NOTE: All relevant references to RfG and DC in the text are consistent with RfG 2.0 and DC 2.0 according to ACER Recommendation No 3/2023 to the European Commission and they are marked as such in the text where necessary.

COMMISSION REGULATION (EU) 20-16/---1447 of ...26 August 2016

establishing a network code on requirements for grid connection of high voltage direct current systems, and direct current-asynchronously connected power park modules, asynchronously connected demand facilities, asynchronously connected power-to-gas demand units and asynchronously connected electricity storage modules

Figure X-a: The frequency ride through profile that an HVDC system should remain connected to the network for the case of over-frequency. The value ta and tb shall be specified by the relevant TSO, but longer than for A-PPMs according to Article 39.

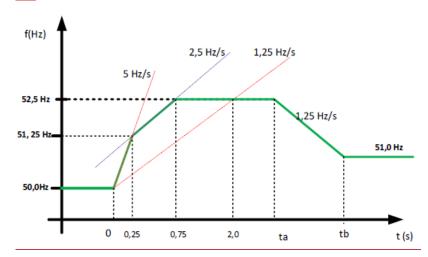
(b) without prejudice to the frequency ranges specified in Annex VI, an HVDC system shall be capable of staying connected to the network and operate at the sequence of rate-of-change-of-frequencies which are defined considering the over frequency against time profiles given in Figure X-a and the underfrequency against time profiles given in Figure X-b;

Figure X-c: LFSM-UC curve for a power-to-gas demand unit

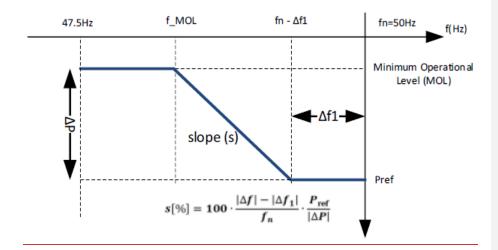
- 7-8. A capability for limited frequency sensitive mode underfrequency consumption (LFSM-UC) for an asynchronously connected power-to-gas demand unit shall be based either on the measured frequency at the power-to-gas demand unit interface point or shall be based on a fast signal response as specified in paragraph 1 for the 50 Hz nominal system. More specifically, the following shall apply:

- (a) the power-to-gas demand unit shall be capable of reducing the consumption from the current active power input automatically down to the minimum technical operational level, according to the indicative Figure X-c at a frequency threshold and with a droop setting specified by the relevant TSO;

- (b) the default setting of the droop slope (%) shall be specified by the relevant TSO:
- (c) the frequency threshold shall be 49,8 Hz (inclusive), except for synchronous area IE and NI, where the frequency threshold shall be 49.5 Hz (inclusive);

Figure X-d: Fault-ride-through profile of a Power-to-Gas Demand Unit.

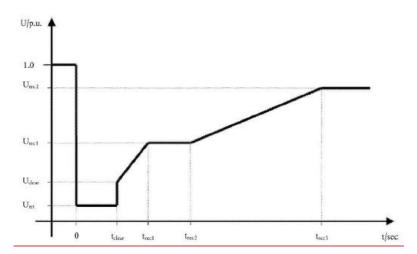
With regard to fault-ride-through capability of asynchronously connected power-to-gas demand units:

(a) the asynchronously connected power-to-gas demand unit shall, when operating above the minimum operating level, be capable of staying connected to the network and continuing to operate stably after the power system has been disturbed by faults in the isolated AC network according to a voltage-against-time-profile in line with Figure X-d and Tables X.1.1 to X.1.2.

Voltage parameters (pu)	
Uret:	0
<u>Uclear:</u>	0
Urec1:	0
<u>Urec2:</u>	0,85

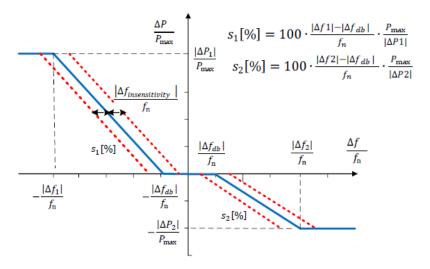
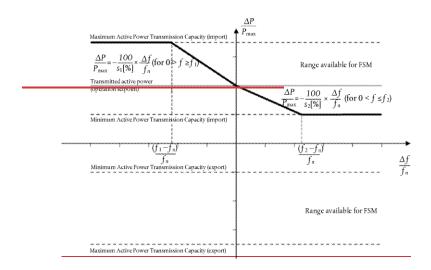
Parameters	Ranges
$\Delta f_1/f_n$, $\Delta f_2/f_n$	<u>0,02-0.06 %</u>
$\Delta f_{ m db}/f_{ m n}$	0-0,01%
Frequency response dDeadband of the FSM, Δf_{db}	0-±500 mHz
Range of the Pdroop s ₁ (upward regulation)	<u>≥</u> Minimum-0,1 %
Range of the Ddroop s2 (downward regulation)	<u>≥</u> Minimum-0,1 %
Frequency response insensitivity, $\Delta f_{insensitivity}$	<u>≤</u> Maximum -30 mHz

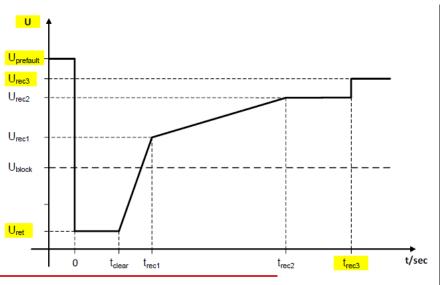
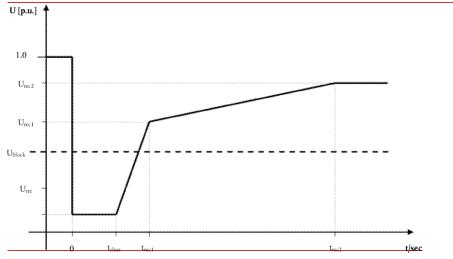
Voltage parameters [pu]		Time _l	parameters [seconds]
U _{ret}	0,00-0,30	tclear	0,14 0,25
Urec1	0,25-0,85	trec1	1,5-2,5
Urec2	0,85-0,90	trec2	T _{rec1} -10,0
<u>Urec3</u>	Minimum voltage specified in Article 40

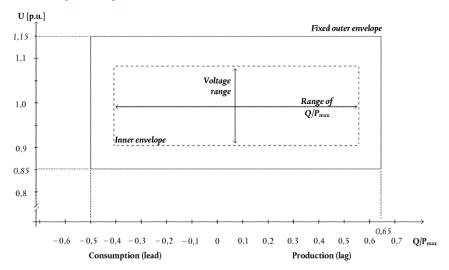
Range of width of Q/Pmax profile	Range of steady-state Voltage level in pu
0-0,95	0,1-0,225
